## Agenda Item #6 Application 2026-19-CA

1557 Eslava Street

After-the-fact alterations to footprint, exterior walls, and building footprint

The house at 1557 Eslava Street is a non-contributing resource within the Leinkauf Historic District. The application under review seeks after-the-fact approval for porch addition, siding replacement, window replacement, and window frame repair.

1. North elevation (façade)

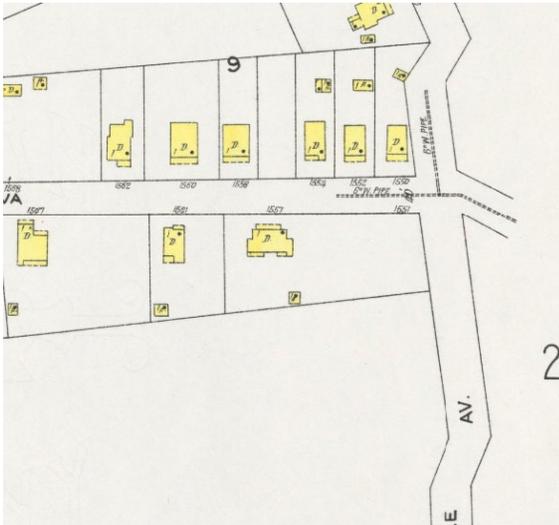
Additionally, the photos from the 2025 property listing show the north façade without the shed roof and gable projection and without the unconnected porches. The *Guidelines* instruct to “replace a historic porch element to match the original” (6.6). The original porch is still existing; it is the enclosed area with the brick columns and fixed picture windows on the north façade. The new porch is a departure from the original in both material and proportion. The *Guidelines* also state that the porch should be designed to be compatible with the neighborhood (6.42). The centered gable with the shed roof projections of the new porch is a unique feature that is not seen on the surrounding homes. There has not been a submitted elevation drawing or plan that shows what the finishes will be for the porch. The current appearance of the elevated portion of the porch does not comply with the *Guideline* to not use raw concrete block or exposed slabs (6.43).

7. View of south (rear) elevation, looking N.

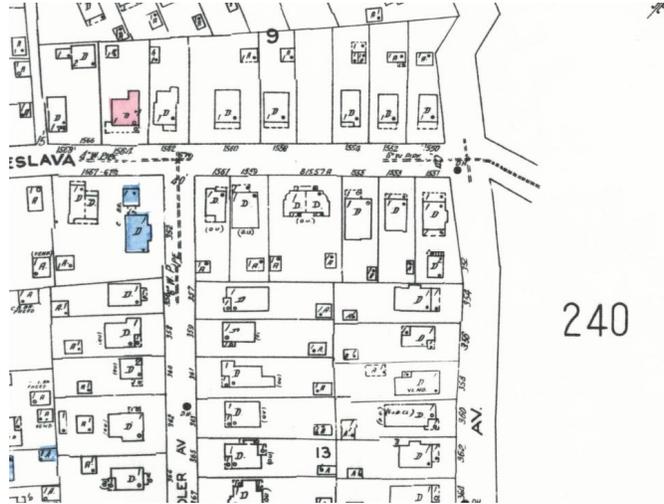
The *Guidelines* state to, “replace exterior finishes to match original in profile, dimension and materials” (5.7). The removed siding material and profile is unknown as it was removed prior to the 311-call. The *Guidelines* also say that “wholesale replacement of exterior finishes is generally not allowed” (5.6). Though the proposed material, fiber cement boar, is an approvable material for use on non-primary elevations.
